CITY OF OXFORD
STAFF SUMMARY REPORT

Agenda Title:	**PC-10-2008 Preliminary Subdivision-South Campus Avenue A Proposed Residential Subdivision in a R2MS Single and Two-Family Mile Square Residential District**

City of Oxford
Community Development Department
STAFF REPORT

RE: Baer Family Trust
Preliminary Subdivision Plan – Campus Commons

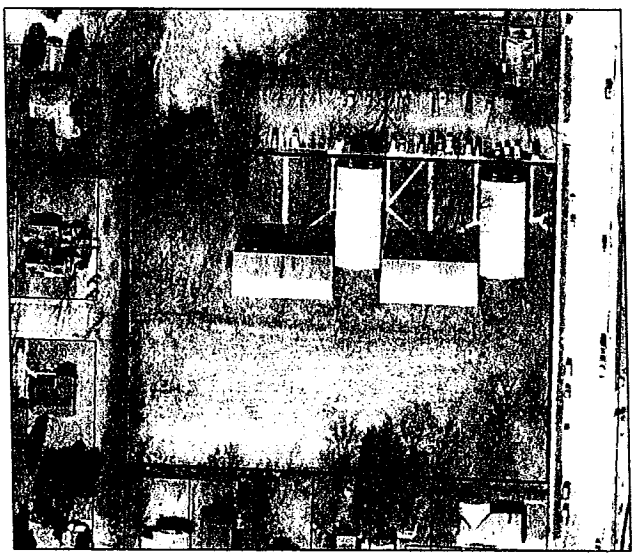
As aforementioned, the Applicant is proposing to modify the existing nonconforming Campus Courts Apartment Complex (48 existing units; 12 units per building; 4 buildings; 2.89 acres) and create a smaller, less conforming lot (1.72 acres) for the apartment complex. Modification to a nonconforming site will require BZA approval, including relief of setback requirements and lot coverage of the existing buildings. Under the current zoning code, this use is not permitted, even as a Conditional Use, in the "R2MS" District. According to the "R3" District, where this use would be permitted, 1,800 sq. ft. of Lot Area per unit is required or 1.98 acres for the existing apartment complex. The Applicant should consider modifying the site plan so the Lot Area conforms to the "R3" requirements.

Lot D12 is required to have a 75 foot lot width along Bern Street. Furthermore, the single-family lot on Bern is required to have a 50 foot lot width and 5,000 sq. ft. of lot area. Approval by the Planning Commission should be contingent upon receiving all necessary variances from BZA.

Lot D20 is an irregular lot with frontage on the proposed Wooster Place extension and Campus Avenue. Access to this lot shall only be permitted from Wooster Place.

Lot D10, Lot D18 and D21 have approximately 30' of buildable depth. Any future decks or patios for these units are required to meet the setback requirements. Future requests for variances of these buildings would not be looked upon favorably.

1. That, all appropriate BZA requests pertaining to the proposed Campus Courts Apartment Complex lots are granted prior to submitting a Final Plat and Construction Drawings.
2. That, all appropriate BZA requests pertaining to Lots D12 and S1 are granted prior to submitting a Final Plat and Construction Drawings.
3. That, ingress/egress to D20 shall only be accessed from Wooster Place and shall not be permitted from Campus Avenue.
